Project Proposal

Property Address 8949 N Greenvale Road

<p>PROJECT/SITE OWNER: John and Karen Hiller</p> <p>PROJECT ADDRESS: 8949 N Greenvale Rd</p>	<p>PROJECT SUMMARY: Replace existing fence with new one</p>
--	---

VILLAGE CODE REVIEW

PLAT OF SURVEY

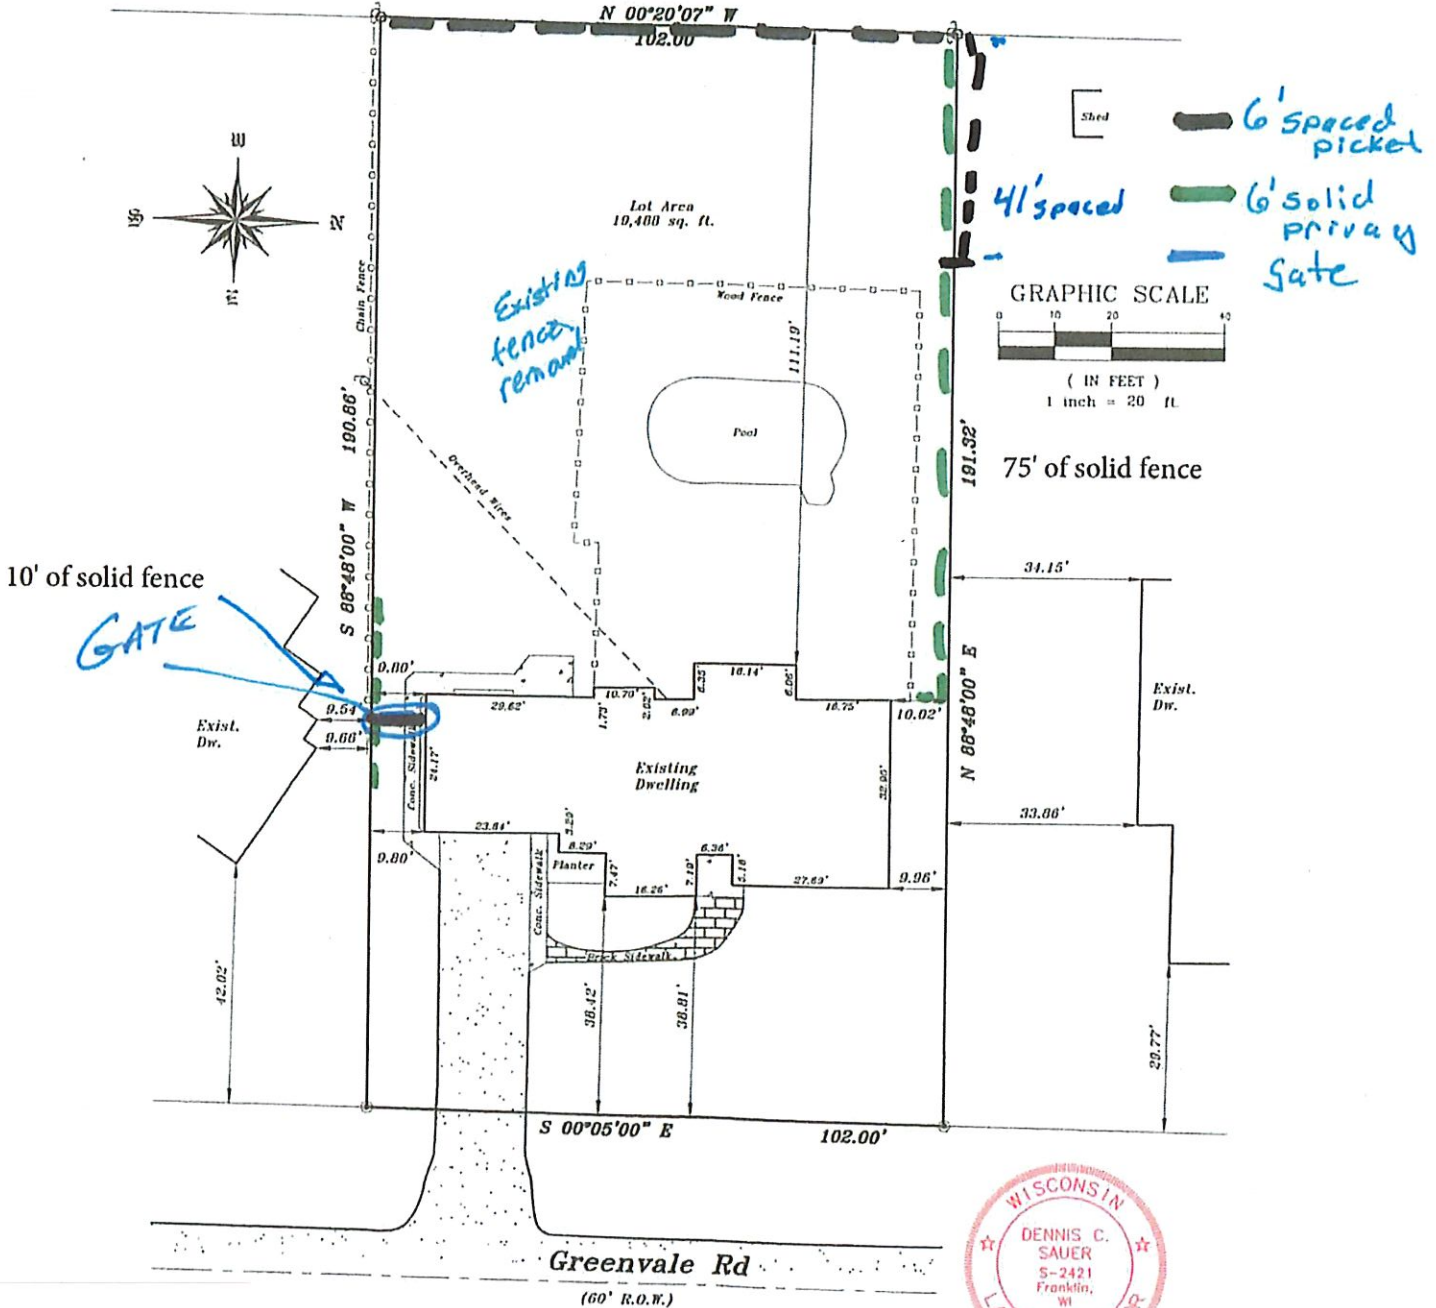
This is based of a revised survey
The application shows a different length for the solid fencing
